# STATE OF ALASKA

## Fairbanks Post Addition Construction

ITB 26MUL0808B

### Amendment Two

1 LEVEL 1 CODE PLAN  
1/16" = 1'-0"

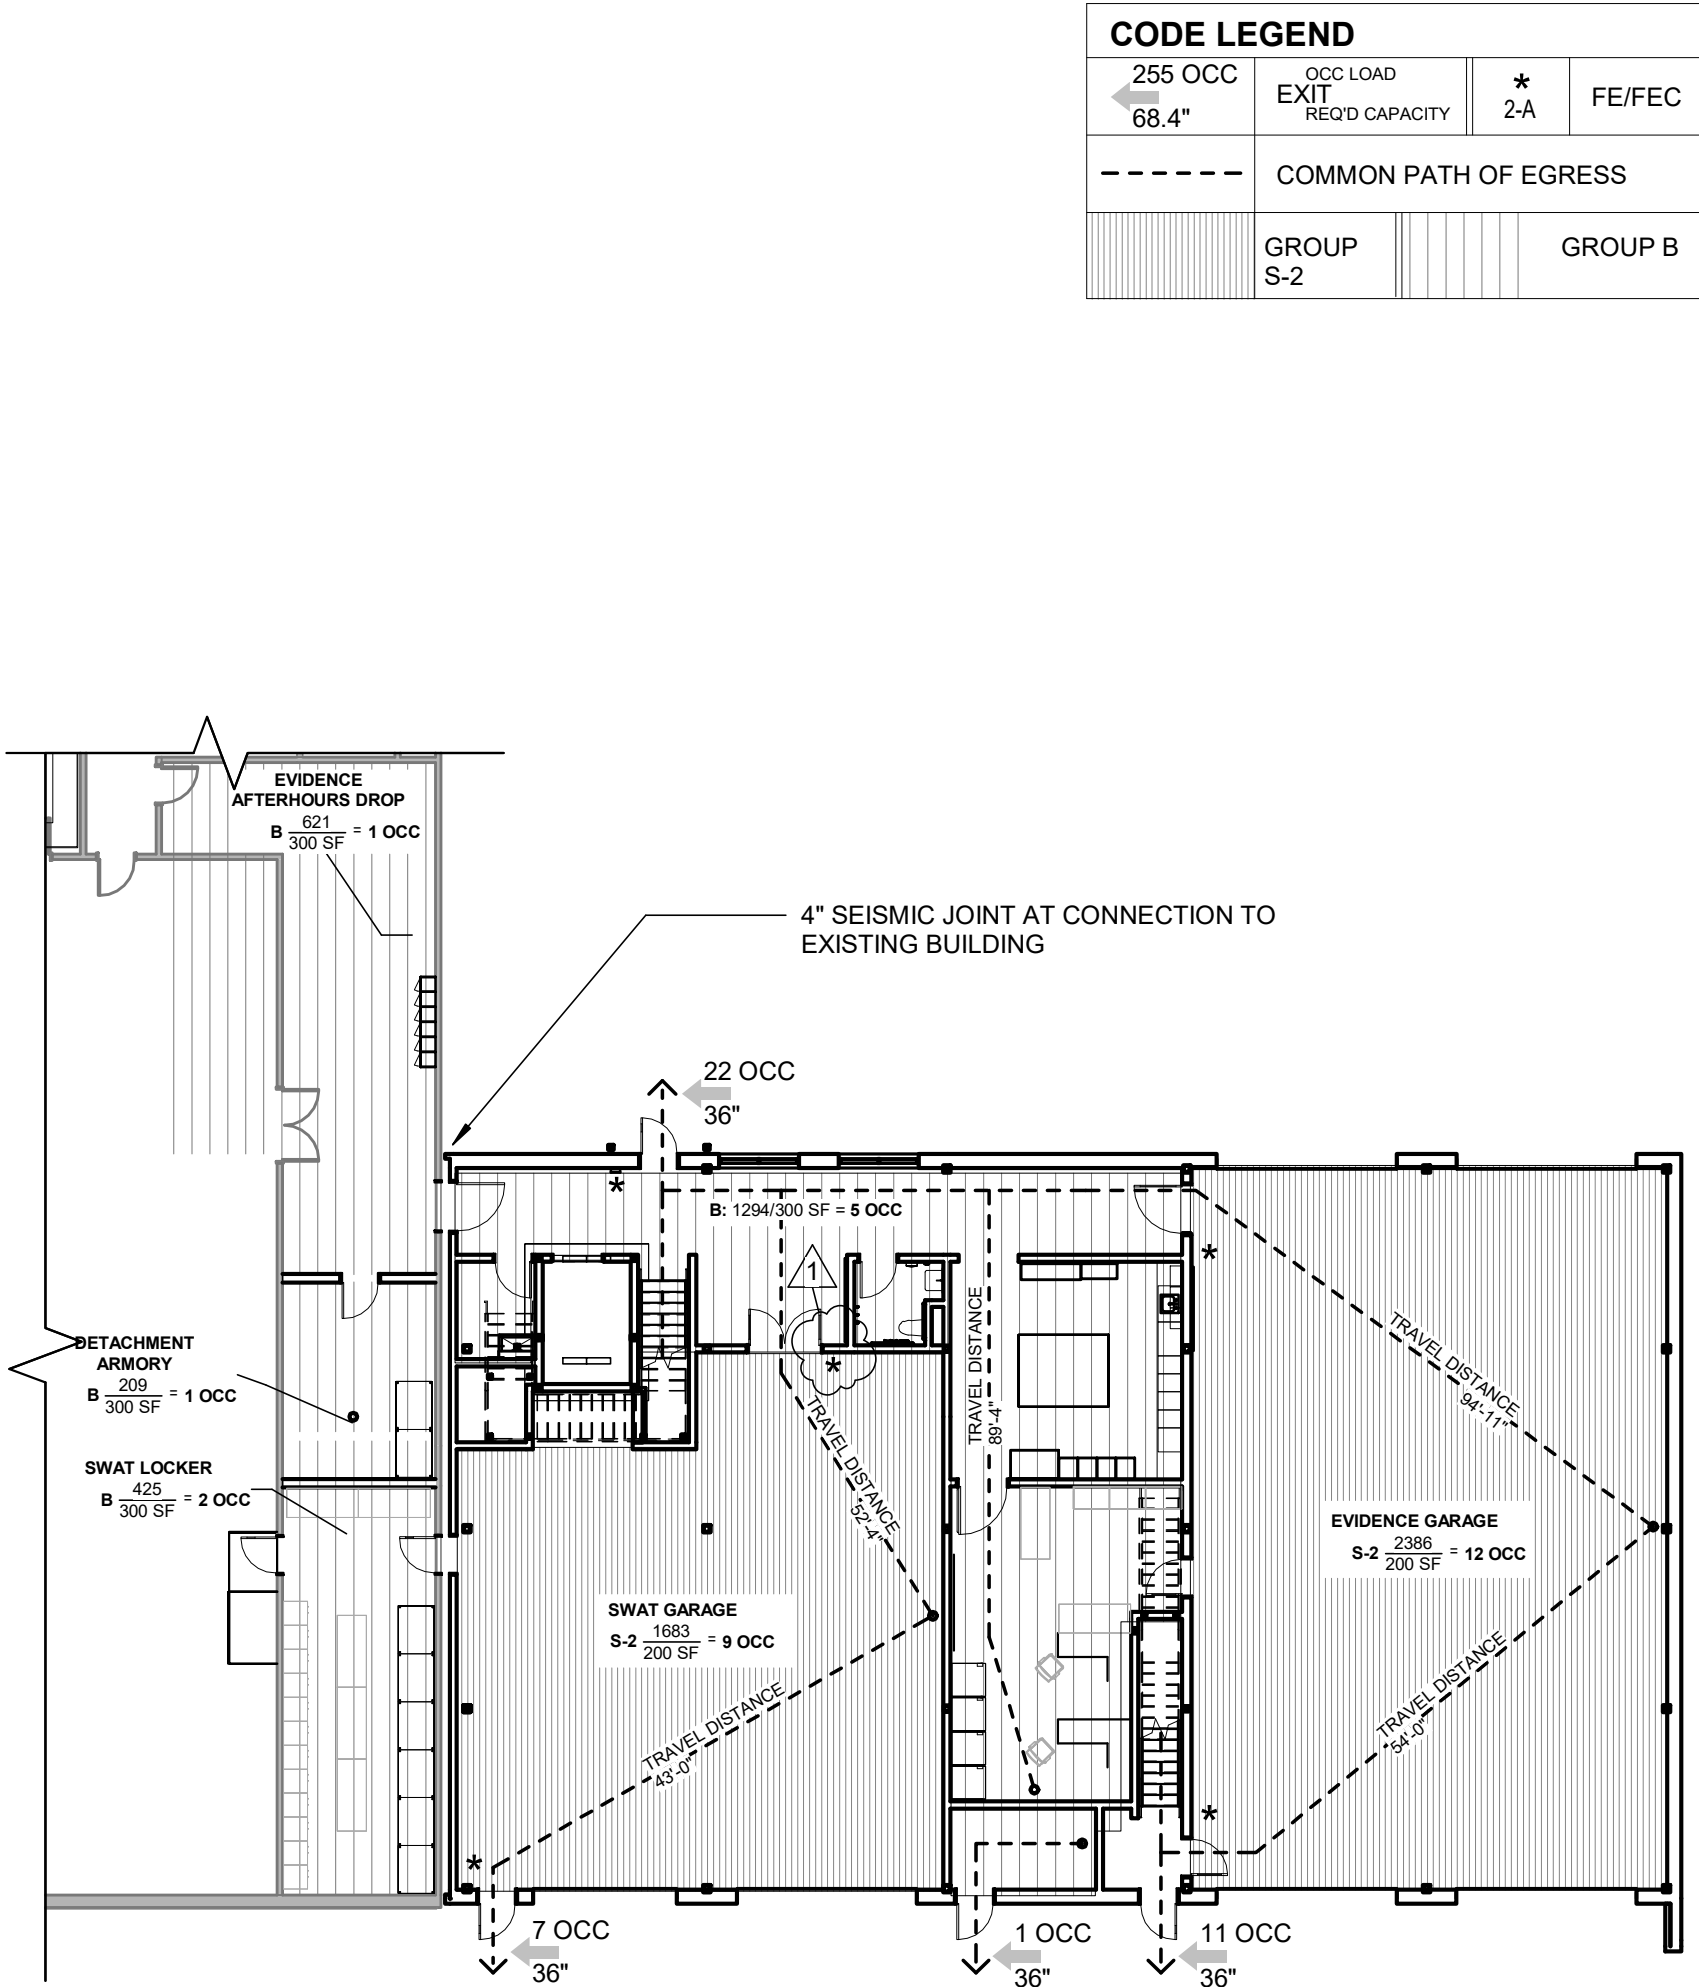
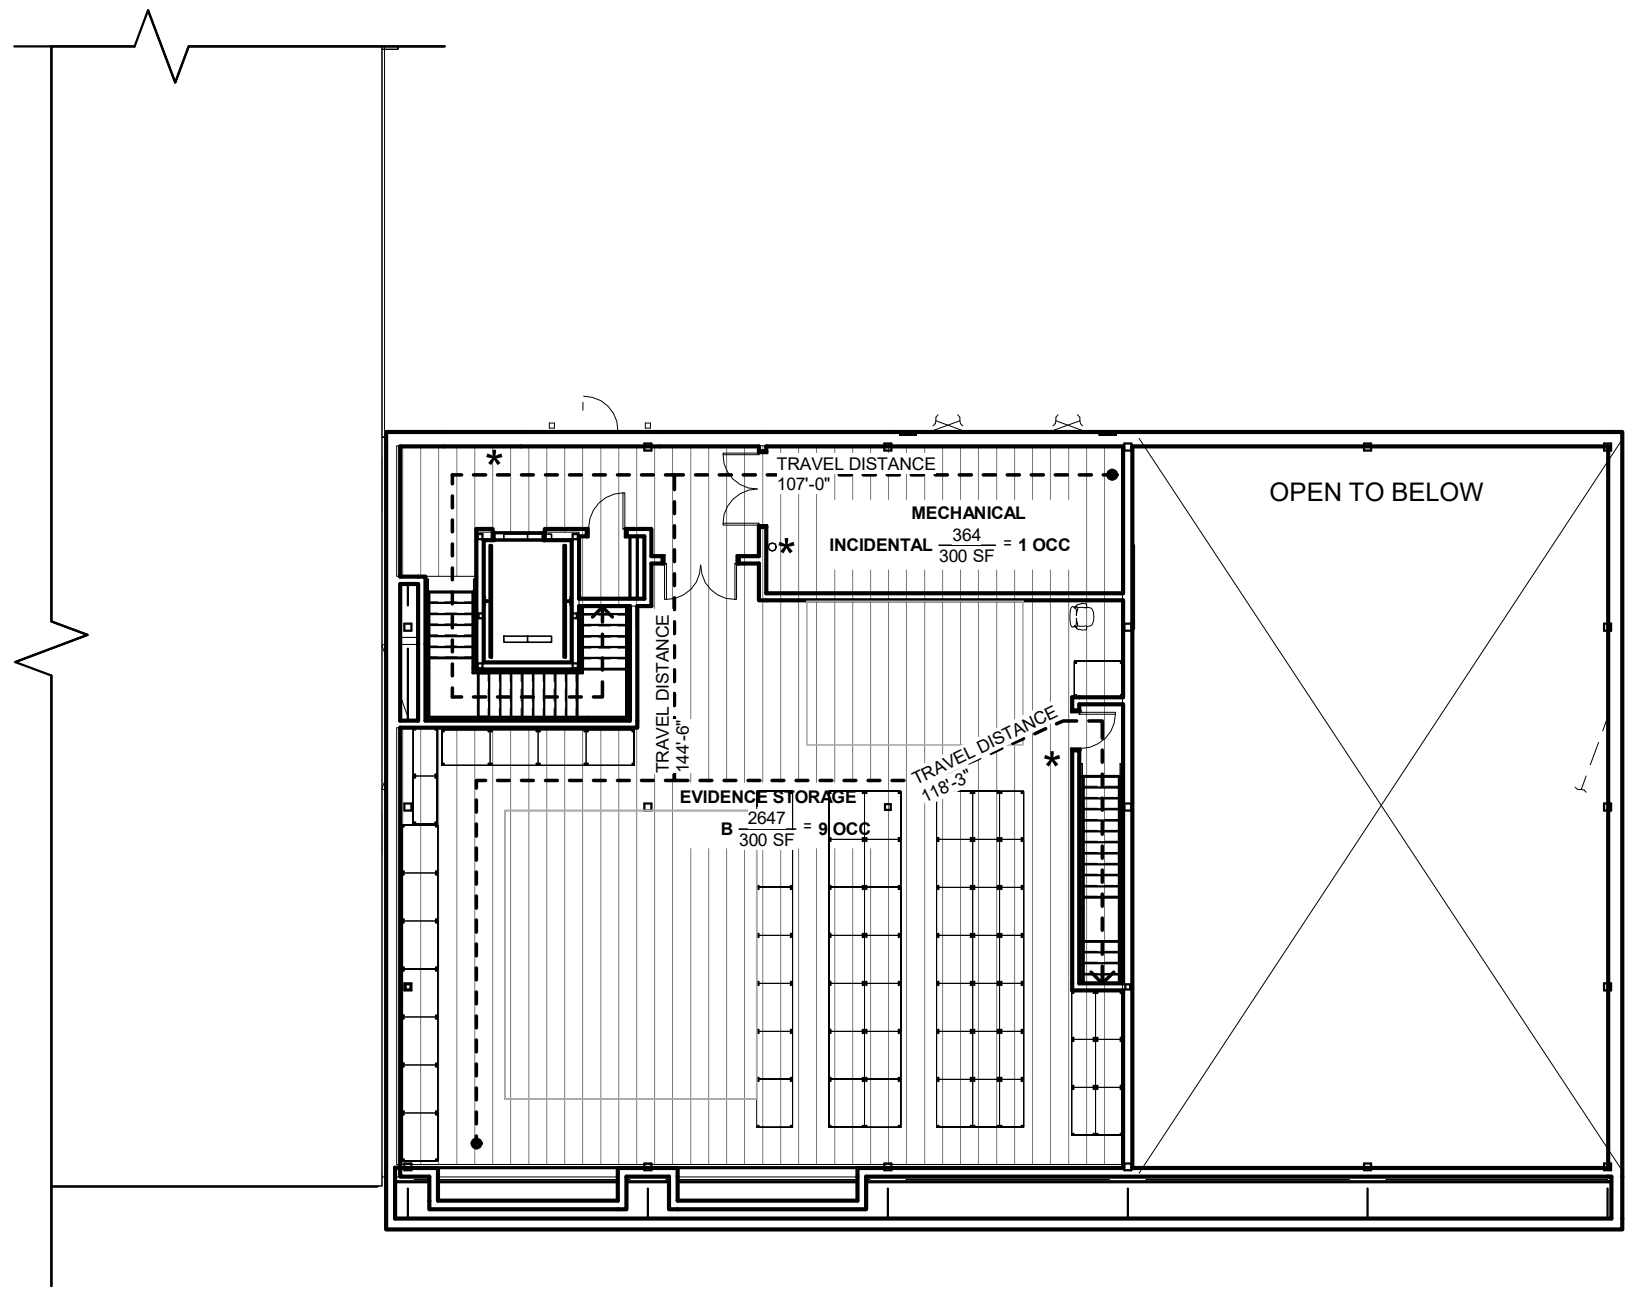
129	The code plan on 1/G102 shows a fire extinguisher in the Swat garage next to door A102A. Sheet A310 shows SWAT Cages in that location. Does this fire extinguisher exist? If so where should it go?	Yes, a wall mounted FE is intended for the North wall of A102 SWAT Garage as noted on Code Plan. See updated 5/A802 and G102 for adjusted location.
130	What gauge is the clip detailed in 8/S402	Bid 12ga/97mil jamb base clip similar to Simpson RCA-C.
131	Sheet A110 shows sawcutting for 3 door openings in the existing corridor, which matches the new floor plan on Sheet A310. Sheet S100 shows sawcutting 4 door openings in the same corridor and a 5th opening along Grid F? Please clarify.	Only 3 door openings to be sawcut in existing corridor consistent with A110. The 4th door opening already exists in the corridor (see A110 and A310). Grid F opening was removed to reuse door already present at corridor end.

1. LEVEL 1 ENLARGED  
1/8" = 1'-0"

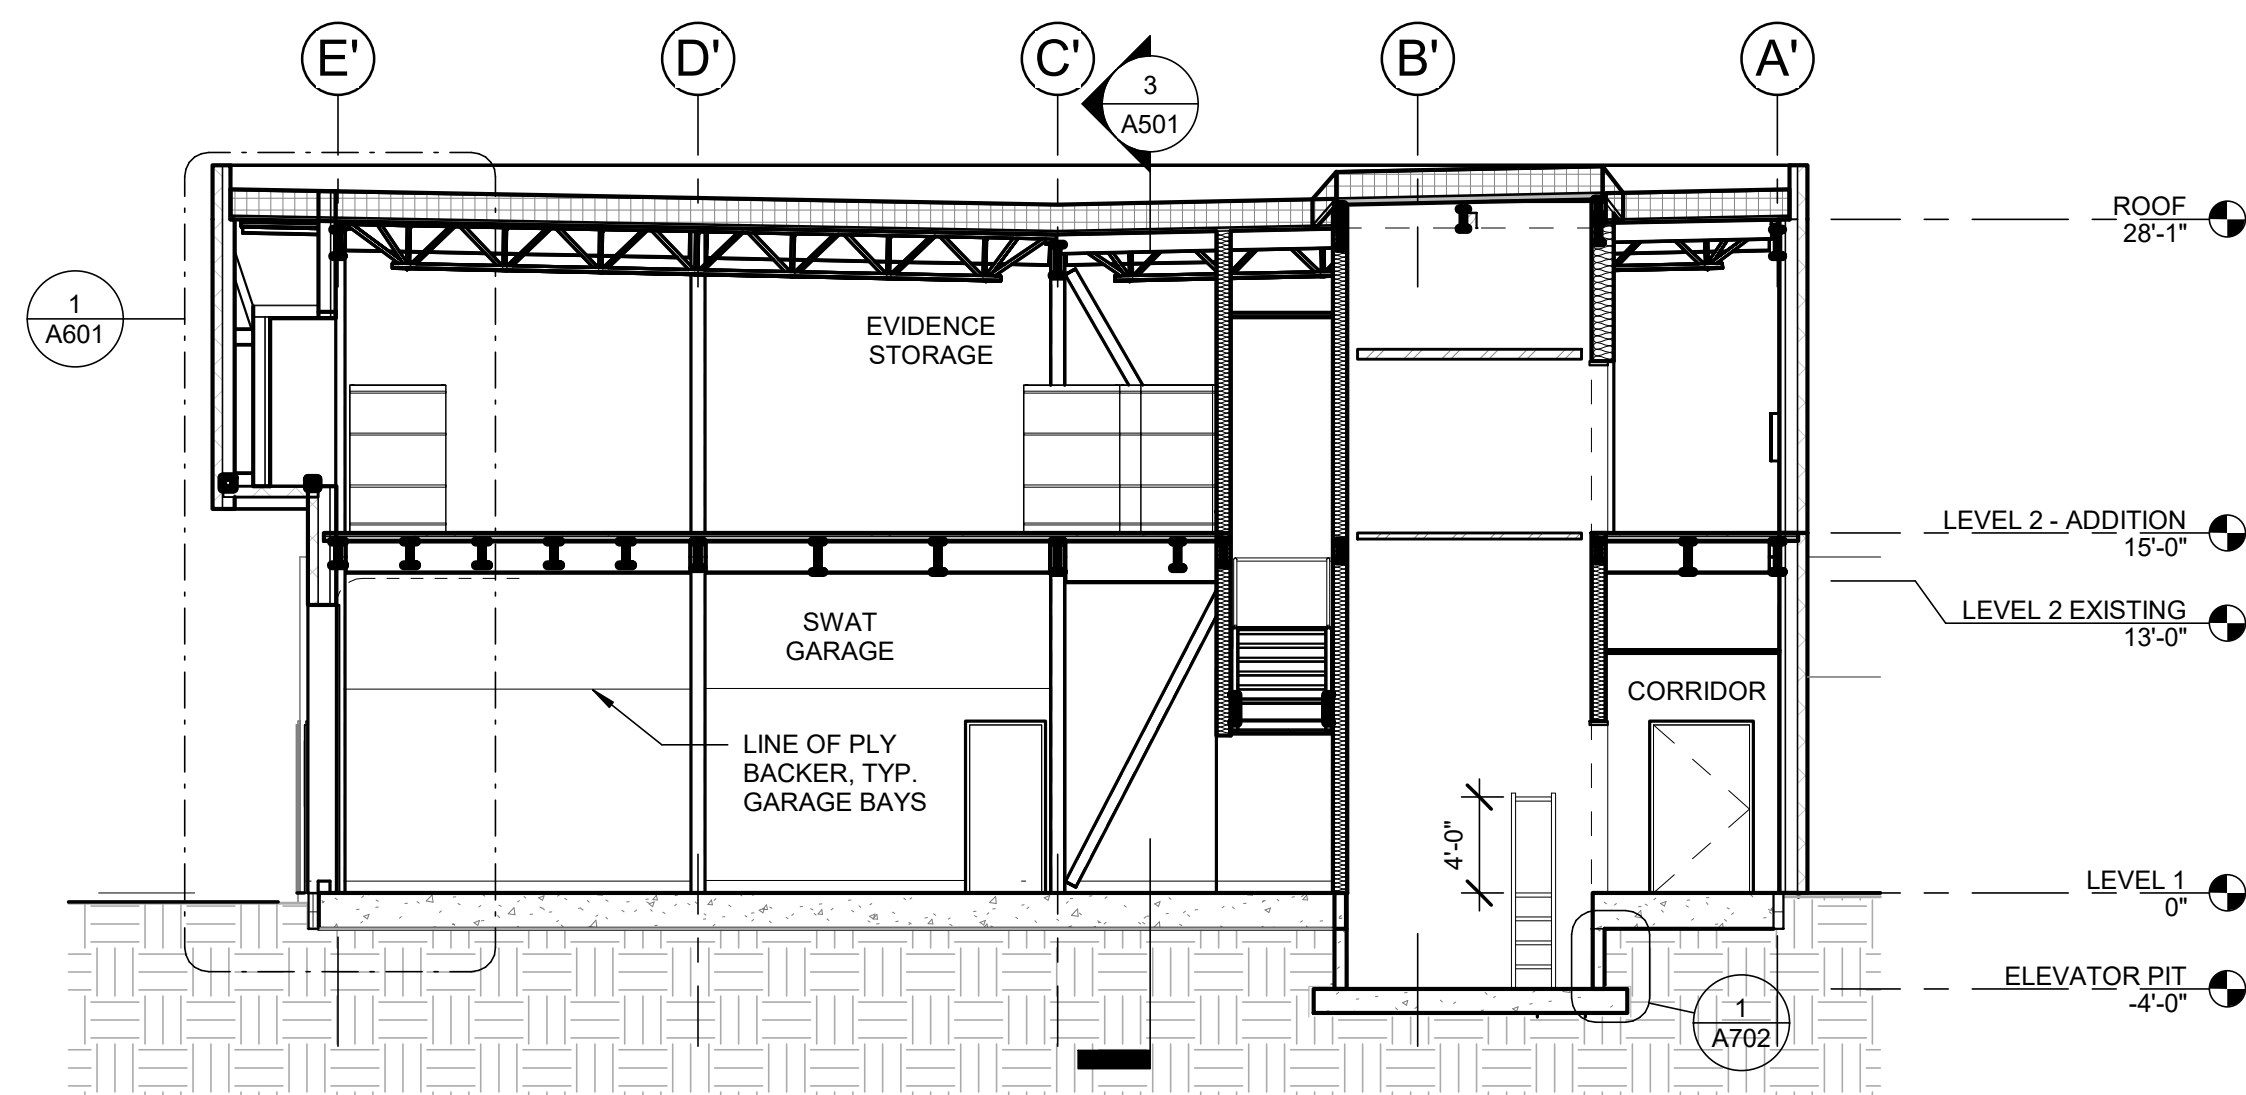
119	1.10 Warranty C 1 it calls out a 3 year installers warranty. The standard is 2 year. Is a 2 year acceptable?	See Question 42.
121	Can another EPDM supplier be used in lieu of Carlisle?	Substitutions: See Section 01 60 00-Product Requirements.
124	Detail 5/A701 shows a W1 interior window under the Stair in the Evidence Open Office. This is the only place this window shows up it is not on any of the plans. The location seems to be the same location of the Dutch door shown in other drawings. Please confirm in this window should be included.	Interior window W1 was replaced with door A105A. See Door Schedule and Type Legend on A1202 for door type. See updated drawing 5/A701.
127	Spec section 07 42 13.23 is titled Concrete Floor Finishes but the text appears to be for metal panels. Is the title or text incorrect?	Title is incorrect. Revise title of Section 07 42 13.23 to 'Metal Wall Panels'
128	Please provide details for the evidence storage cages shown in Evidence Garage A106 on Sheet A310.	Details 2/A310 and 3/A310 are typical for all evidence storage cages in A102 and A106.
